SERVICE BULLETIN

B-063A

Safety Recall Code 0832

SIDESTAND ASSEMBLY REPLACEMENT FOR 2006 ULYSSES XB12X

Figure 1. Old Pivot Bolt and New Pivot Pin with Circlip

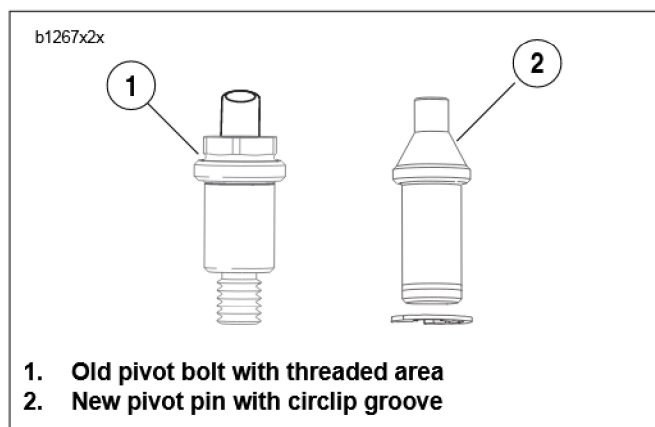
Either the pivot bolt for the sidestand leg or the mounting bracket bolts could break, possibly without notice. If either of these failures occurs, the motorcycle could fall, possibly causing death or injury.

See Figure 1. The correction for this issue is to replace the sidestand assembly and fasteners. The recall kit Part No. is 94483Y.

Figure 3. Sidestand Assembly (Extended)

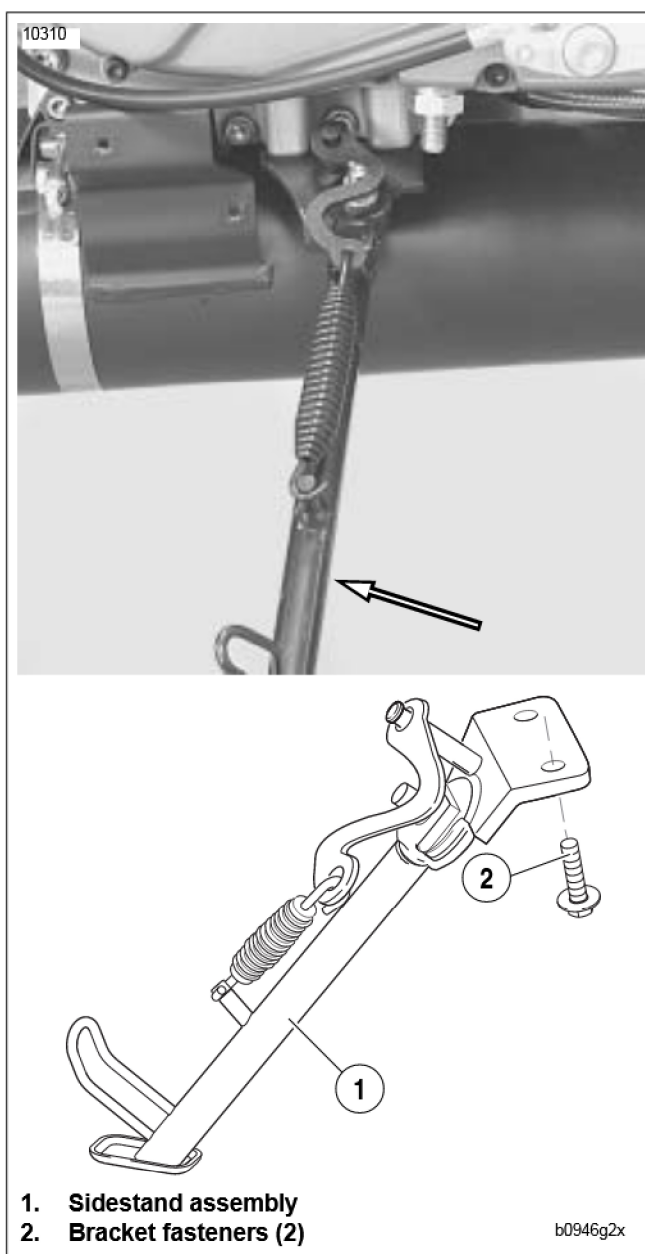
1. Place vehicle on suitable lift so it is not resting on the sidestand.
2. Remove chin fairing fasteners. See 2.38 CHIN FAIRING in Ulysses Service Manual.
3. Remove muffler. See Muffler and Straps in 2.32 EXHAUST SYSTEM in Ulysses Service Manual.
4. See Figure 3. Remove fasteners (2) securing sidestand assembly (1) to engine and remove sidestand assembly.

1. See Figure 3. Loosely install the sidestand assembly (1) to the crankcase with **new** sidestand bracket fasteners (2) provided in recall kit. Extend the sidestand leg (1) and hold forward in the fully extended position while tightening the sidestand bracket fasteners (2) in the following sequence:
 - a. Tighten the front fastener to 25-27 ft-lbs (34-37 Nm).
 - b. Tighten the rear fastener to 25-27 ft-lbs (34-37 Nm).
 - c. Repeat the tightening sequence in step a and b to verify proper clamp load.
2. Install muffler using **new** Torca clamp and front muffler strap provided in recall kit. See Muffler and Straps in 2.32 EXHAUST SYSTEM in Ulysses Service Manual.
3. Install chin fairing fasteners. See 2.38 CHIN FAIRING in Ulysses Service Manual.
4. Extend and retract sidestand leg to check for proper operation.
